April 27, 2007

Re: NPDES Proposed Permit – Dry Creek Rancheria Band of Pomo Indians

Figure 2-1  
Proposed Parcel Development

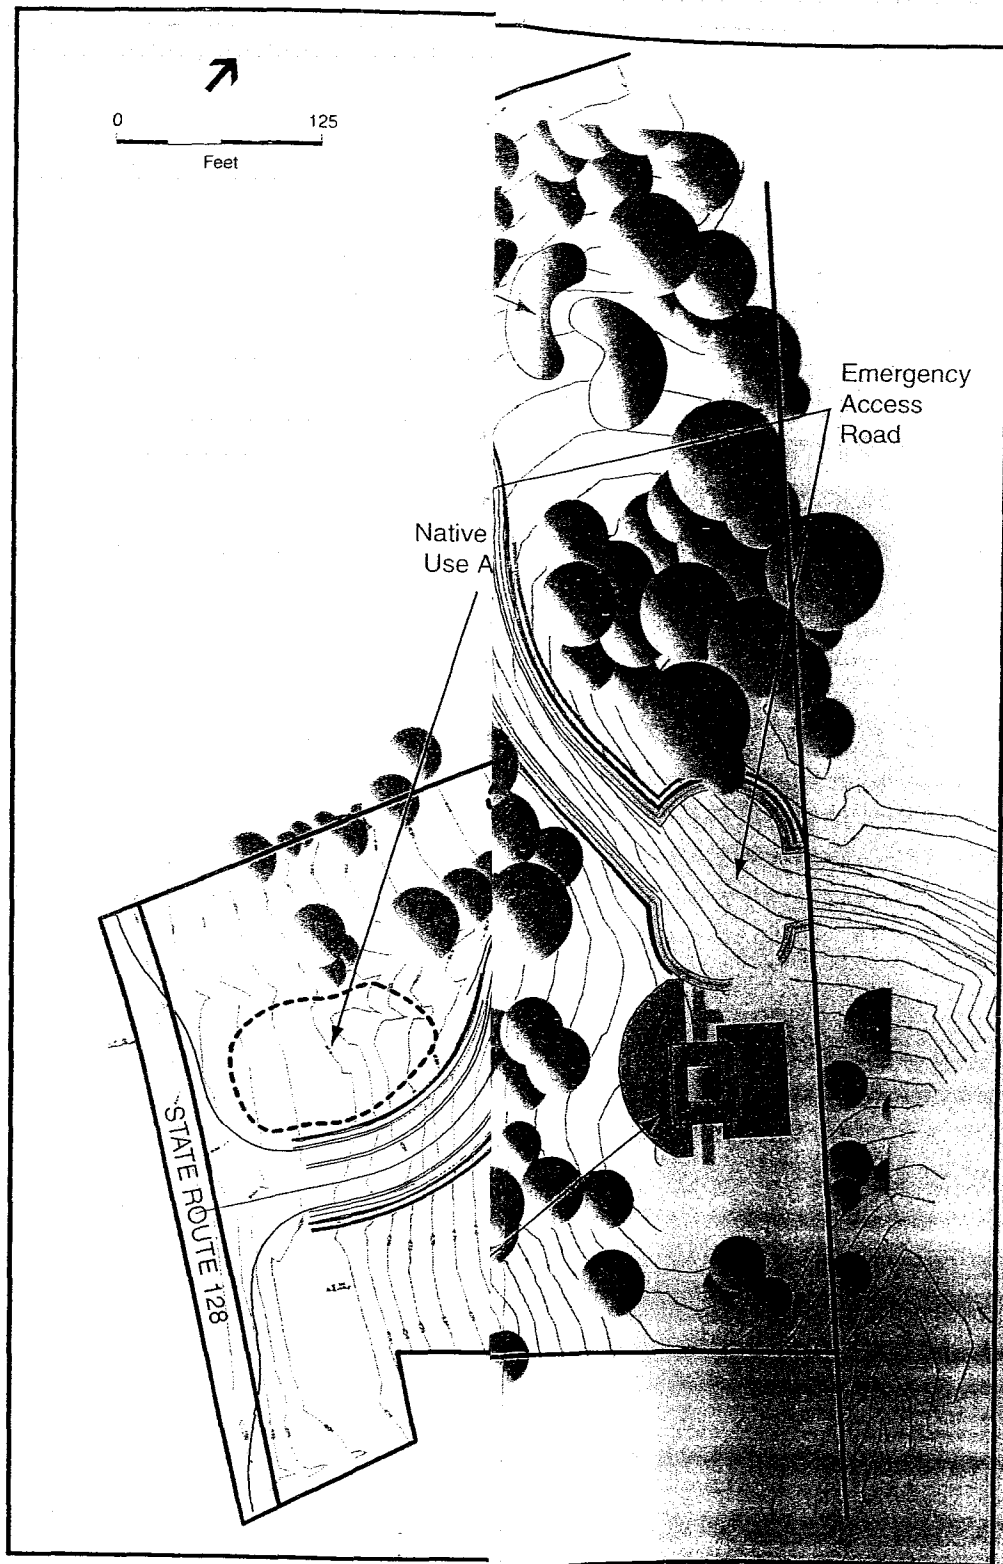
The Tribe's spreadsheet also states that the Tribe will have up to twelve acres for irrigation going forward. The memorandum assumes all twelve acres will be planted with turfgrass (Memo at 3), but provides no further detail. The County is not aware of an additional seven acres in the area planted with turfgrass. The Tribe did acquire the 18-acre "Dugan" parcel south of the Rancheria in 2003, but that parcel does not contain turfgrass, and is not proposed for turfgrass in the future. The Tribe has instead applied to develop the property with residences, an emergency services building, vineyards, a winery and tribal offices, roads and other infrastructure, and two small native plant areas. (See Enclosure.) Vineyards and native plants require far less water than turfgrass.

EPA should require the Tribe to revise its water balance information to specifically identify the locations of its proposed irrigation, the plant species to be irrigated, and revised calculations supporting its proposed irrigation levels. The County cannot conduct a meaningful review of the Proposed Permit without this information.
